K3 KIT ASSEMBLY MANUAL ERRATA

Rev. M-2, March 2, 2015

A new synthesizer pc board is now being shipped for your K3. The following changes are required to install the new board. The new and original synthesizer boards are shown below:

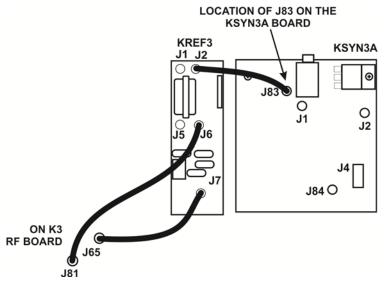
Page 53: Before installing the new KSYN3A, check and trim the leads as shown below to avoid short circuits against the front panel shield.

CHECK AND TRIM AS NEEDED SO THEY ARE LIKE THE LEAD BELOW

The new KSYN3A synthesizer is installed as shown for the previous synthesizer, except that the mounting screws are now zinc $4-40 \times 1/4$ " pan head, and the two split lock washers between the synthesizer board and the front shield are <u>not used</u>. Tighten screws securely, since the on-board voltage regulator relies on them for heat sinking, but take care not to over-tighten the screws and damage the pc board.
